TAL-CO SUPPLEMENTAL INSTRUCTION #23			
Project Name:	RW TOMLINSON - NEW HEAD OFFICE		
Project Location:	100 City Gate Drive, Ottawa, Ontario		
ARCH. SI #:	ASK #'s 50, 51, 52	Issued By:	Chris Simpson
STRUC. SI #:	N/A	Date Issued:	December 21, 2016
MECH. SI #:	N/A	Revision #:	N/A
ELEC. SI #:	N/A	Revision Date:	N/A

Title: Details of water wall in main atrium (Grid C between 2 & 3)

DRAWING No:
ASK-50

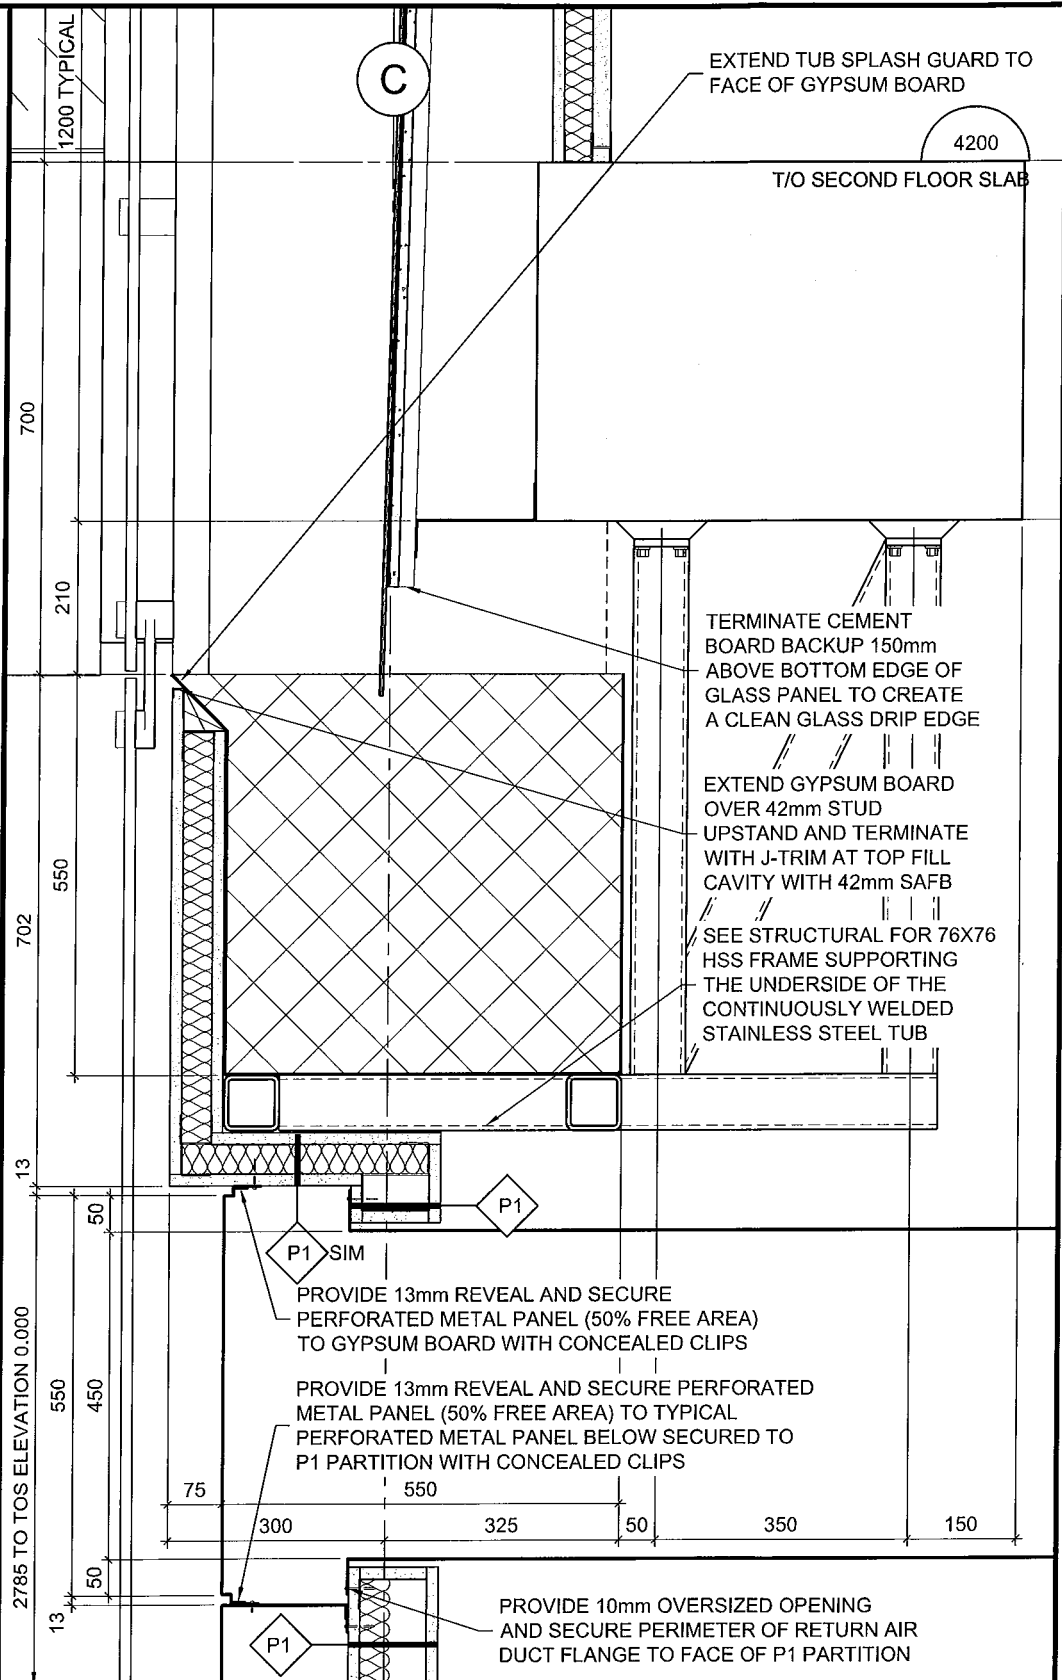
TYPICAL WATER FEATURE DETAIL

DRAWING TITLE:
REFERENCE NEW DET. AS INDICATED

DRAWING No:
ASK-51

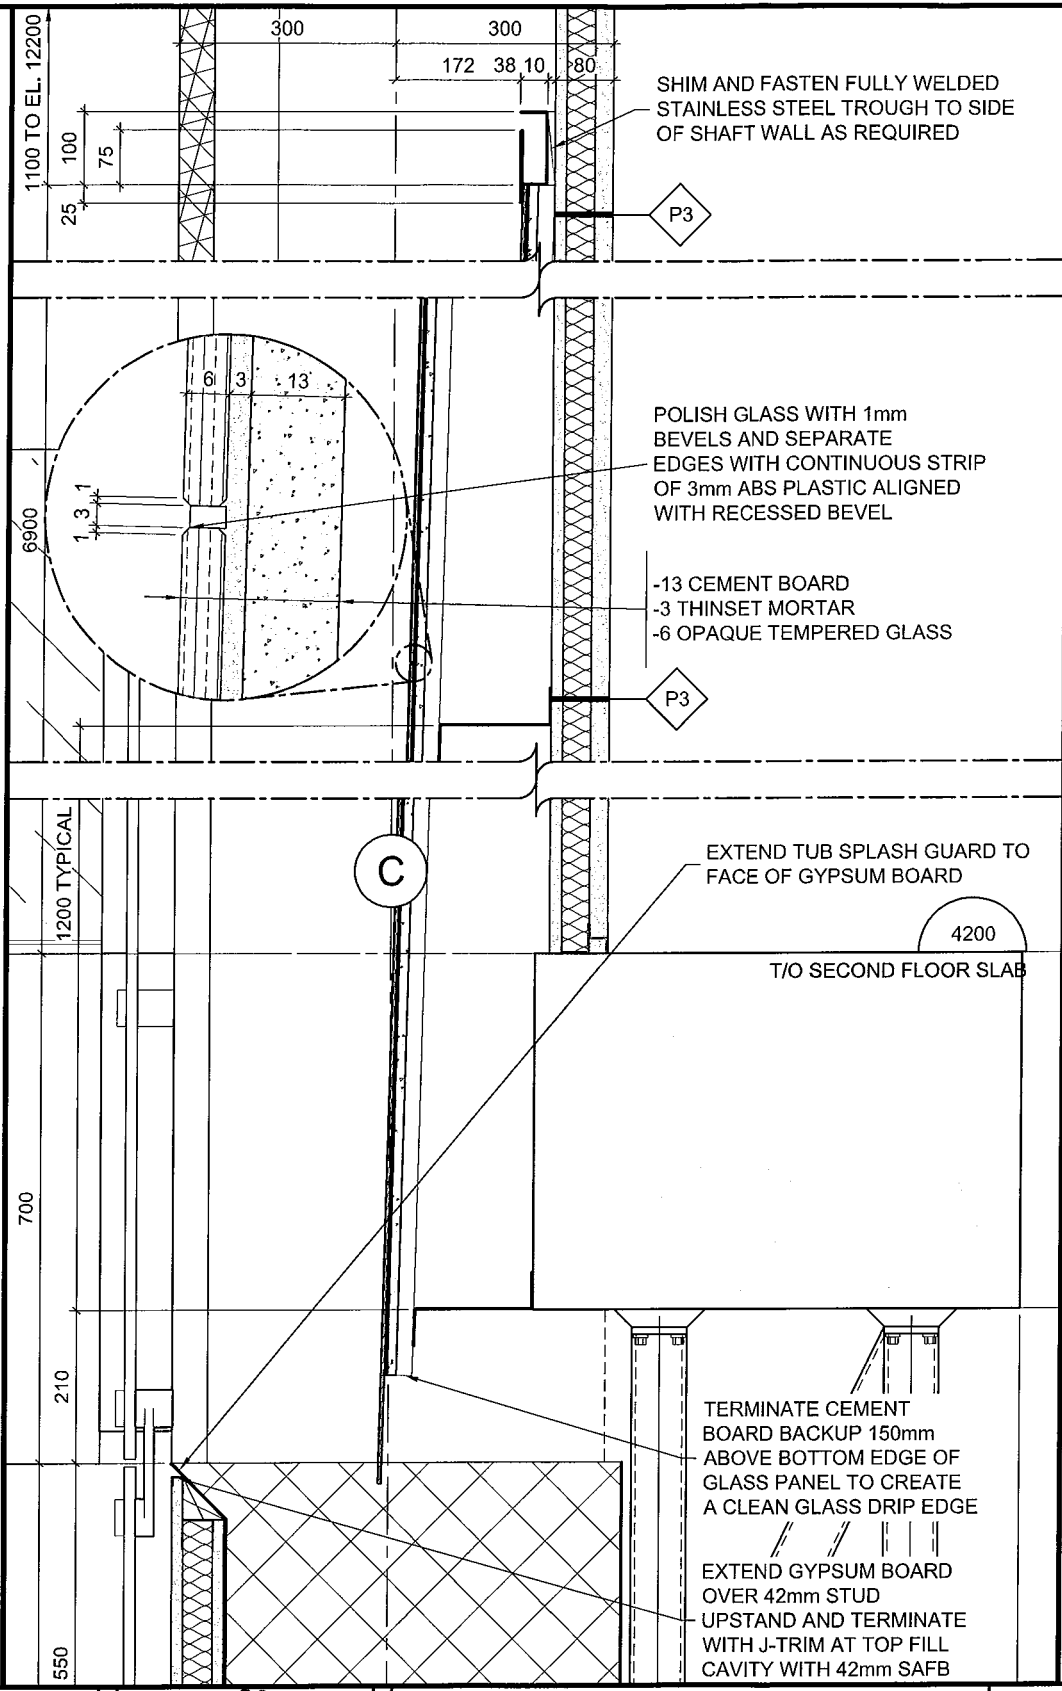
DRAWING TITLE:
REFERENCE PART. NEW DETAIL 2/A604
